Docket Item # 3
BAR CASE # 2010-0196

BAR Meeting
July 28, 2010

ISSUE: Request for Approval of New Construction
APPLICANT: Wanda Carter
LOCATION: 219 North West Street
ZONE: RB / Residential

Figure 1: Applicants earlier proposal showing a cross gable roof with parapets at the front, now simplified.

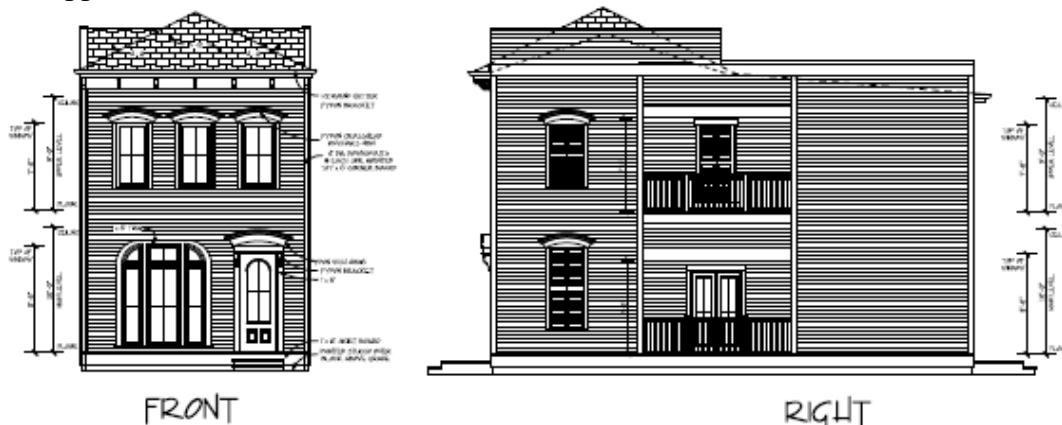
As shown by the illustration in Figure #1 above, the earlier complex roof forms have now been simplified and the trim has been refined. Early proposals were very handsome houses but had more in common with high style Charleston or New Orleans dwellings. The applicant has, therefore, used images of several historic buildings in the Parker-Gray district as inspiration but has not copied any of these directly.
